Expert Witness Report Urban Design Evidence

Hume Planning Scheme
Amendment C207

Sunbury South Precinct Structure
Plan

35 Buckland Way Sunbury

Figure 5: Exhibited FUS Sunbury South PSP – Harpers Creek Local Town Centre Concept Plan.

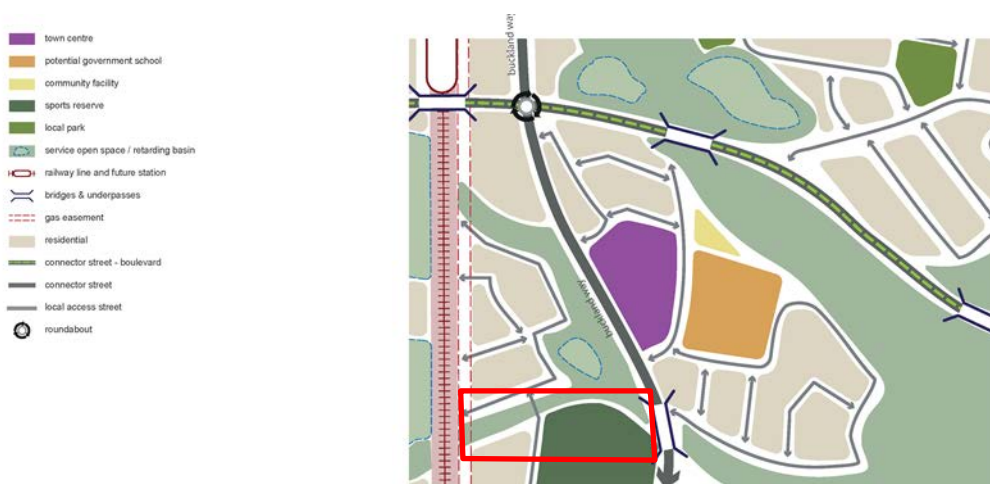
After reviewing the supplied material, I provide the following comments relating to the location of the Harpers Creek LTC and its impact on 35 Buckland Way:

- LTC's should be located central to the residential catchment that they serve. This Local Town Centre is heavily constrained with regards to servicing the residential catchment due to natural topography and creek lines.

- On average, for a full line supermarket to establish, a catchment of 8,000 to 10,000 people to make a supermarket commercially viable. The challenge for LTC is the physical constraints which exist between it and the catchment that it serves.

- In an ideal situation, the LTC would be located closer to the proposed rail line but I understand the challenges associated with the LTC in this location.

- The LTC will be well connected via key road and open space connections. However, the immediate surrounding residential catchment is limited.
- Due to the limited catchment of the LTC, physical access to the centre is critical. The location of signalised intersections and dedicated crossing points to allow movement east-west across Buckland Way is crucial.

1. The location of the LTC is central to the residential catchment, despite the physical access challenges. If consideration was to be given to moving the LTC, it should be closer to the proposed rail line.

2. Due to the physical constraints around the LTC, opportunities to increase residential development within a walkable catchment of the LTC should be explored. This will assist in activating the LTC and providing an immediate catchment for a LTC to be viable.

3. Look at ways to improve the physical permeability of the LTC particularly across Buckland Way. This should be for vehicle, cycle and pedestrian movements.

4. 35 Buckland Way can assist in addressing these items in the following ways:
 - a. The review of drainage on the site (refer section 2.1.4 for further information) allows the majority of the east-west linear waterway to be piped. This frees up land within walking distance to the LTC for residential development;

- b. A road needs to exist in the previous location of the east-west linear waterway to cater for overland flow. This allows an opportunity for an intersection at the southern end of the LTC which would provide east-west connection across Buckland Way.

- c. There is an opportunity to shift the Active Open Space further (refer section 2.1.3 for further information) which would further increase developable land within a walking catchment of the LTC.

Figure 8: Exhibited Sunbury PSP – Integrated Water Management

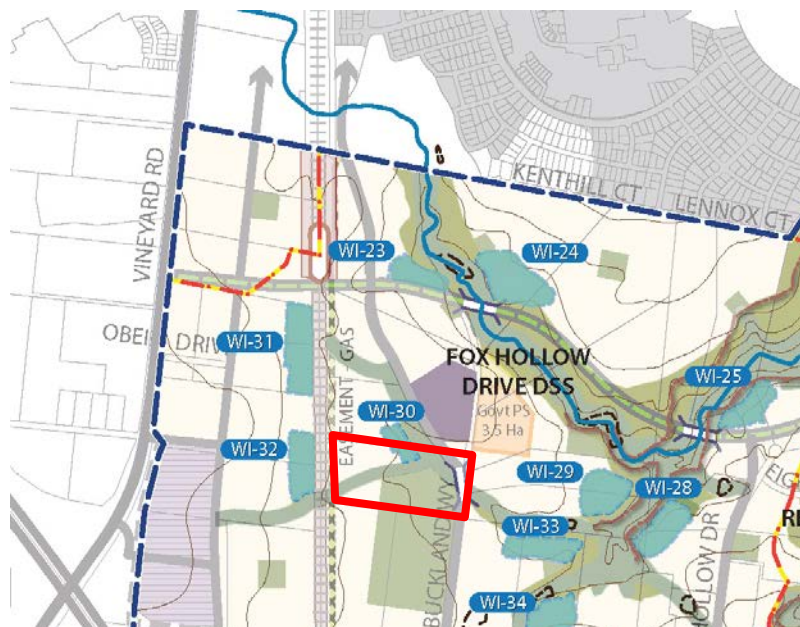
Based on the information received from Echelon Planning and the expert advice received from Nina Barich (Principal Engineer) regarding the drainage reserve. Ms Barich has confirmed that the drainage reserve could be piped. In its place, a road would need to be established to cater for the overland flows in the area.

1. Recommend adopting Nina Barich's advice regarding piping flows rather than a drainage reserve.
 - a. This results in freeing up developable land within the walking catchment of the LTC
 - b. This also allows for an east-west road to connect the LTC to the west of Buckland Way which can also function as the overland flow path to replace the drainage reserve
 - c. The ability to provide an appropriate interface to the north of the Active Open Space can be achieved through a road interface, medium density residential now that more developable land is available.

Figure 9: Exhibited Sunbury PSP – Image and Character

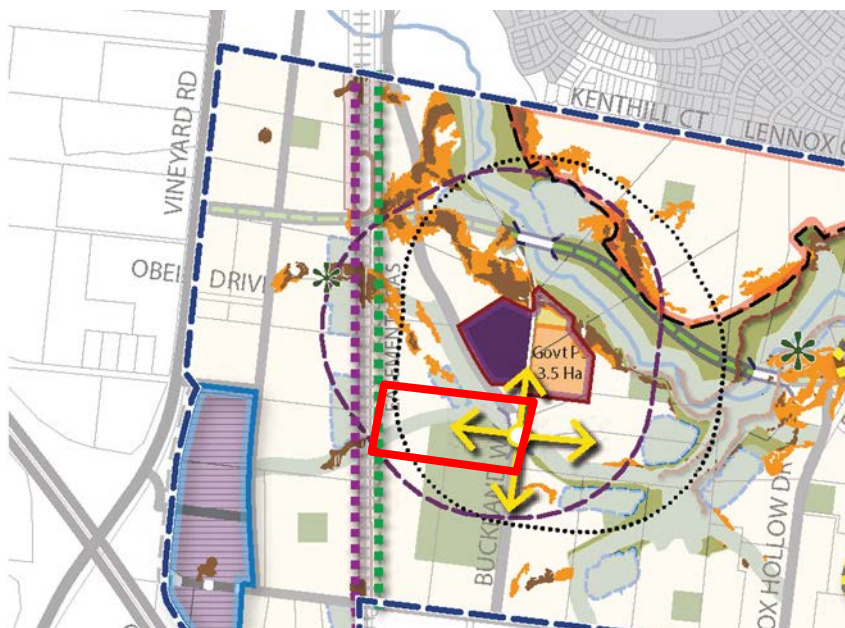
After reviewing the supplied material, I provide the following comments relating to residential development, density and impact on 35 Buckland Way:

- Within the 400m radius of the LTC location, there are limited opportunities to establish densities at 17 dwellings per net developable hectare, due to existing topographic and open space constraints;
- Within the 200m radius of the Community Hub location there are limited opportunities to establish densities at 17 dwellings per net developable hectare, due to existing topographic and open space constraints;
- Within the 800m of train stations, there are limited opportunities to establish densities at 17 dwellings per net developable hectare, due to existing topographic and open space constraints.
- In addition to the above, the ability to establish medium density housing in locations with good access to these locations as well as opportunities for high amenity should be investigated.

1. Recommend adopting the previous recommendations within this report which are:
 - a. The advice to pipe overland flow rather than retain a drainage corridor; and
 - b. Moving the Active Open Space further south.
2. Based on these two recommendations, a significant amount of developable land will be made available which will:
 - a. Assist in creating a local walkable catchment for the LTC and rail station;
 - b. Deliver an east-west connection for vehicles, cyclists and pedestrians across Buckland Way to the LTC;

- c. Provide appropriate interface to the northern boundary of the Active Open Space through road frontage and appropriate built form outcomes;
- d. Increase the densities within the catchments of the rail station, LTC and Community Hub by freeing up more developable land; and
- e. Medium density development delivered in close proximity to amenity, transport, Active Open Space and local services and amenities.

Figure 10: Design Options – 35 Buckland Way

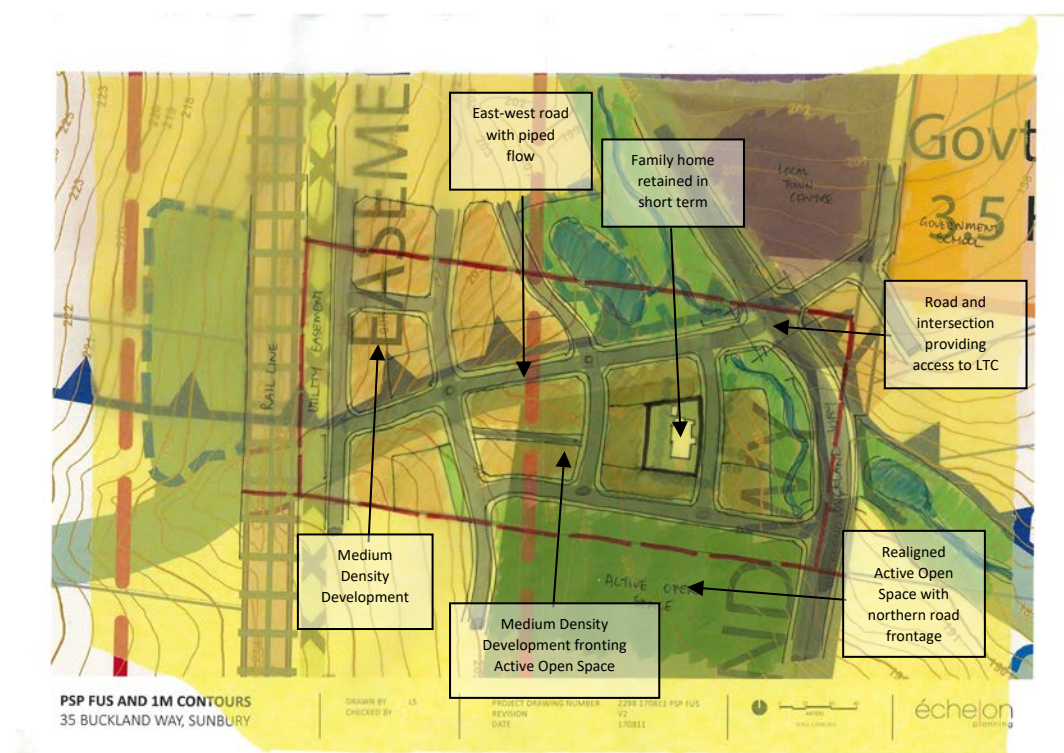
The key changes are:

- Adopting the drainage changes as per Echelon Planning and from Nina Barich (Principal Engineer). A Connector Road now runs in place of the drainage reserve providing the opportunity to pipe the flow with overland flow also accommodated within the road reserve.
- Shifting the Active Open Space south. This allows the Connector Road to intersect with the southern portion of the LTC and provide crucial east-west connection across Buckland Way. Appropriate frontage to the Active Open Space has also been

achieved through road frontage and medium density development facing the Active Open Space. This concept also reflects the outcomes demonstrated in the MEMLa Active Open Space concept plan.
